BUILDING PERMIT REPORT

ADDRESS: 138 LYNN ST.

REASON FOR PERMIT: Finish off second floor (2) bedrooms  
and bath room

SECOND FLOOR UNFINISHED

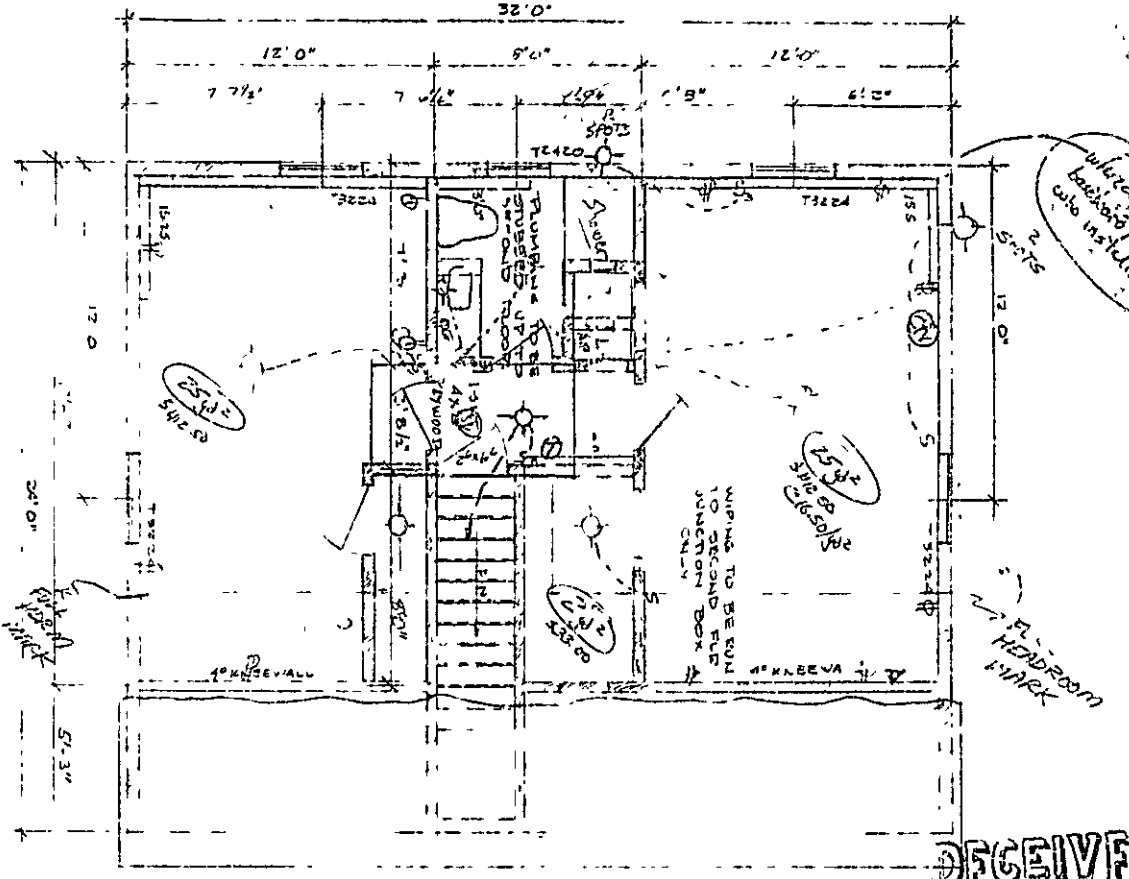
- \* 6.) Every sleeping room below the fourth story in buildings of Use Groups R and I-1 shall have at least one operable window or exterior door approved for emergency egress or rescue. The units must be operable from the inside opening without the use of separate tools. Where windows are provided as a means of egress or rescue, they shall have a sill height not more than 44 inches (1118 mm) above the floor. All egress or rescue windows from sleeping rooms must have minimum net clear openings of 5.7 square feet (0.53m<sup>2</sup>). The minimum net clear opening height dimension shall be 24 inches (610 mm). The minimum net clear opening width dimension shall be 20 inches (508 mm).

- \* 7.) In addition to any automatic fire alarm system required by Section 1018.3.5, a minimum of one single station smoke detector shall be installed in each guest room, suite of sleeping area in buildings of Use Groups R-1 and I-1 and in dwelling units in the immediate vicinity of the bedrooms in buildings of Use Group R-2 or R-3. When actuated, the detector shall provide an alarm suitable to warn the occupants within the individual unit (see Section 1717.3.1).
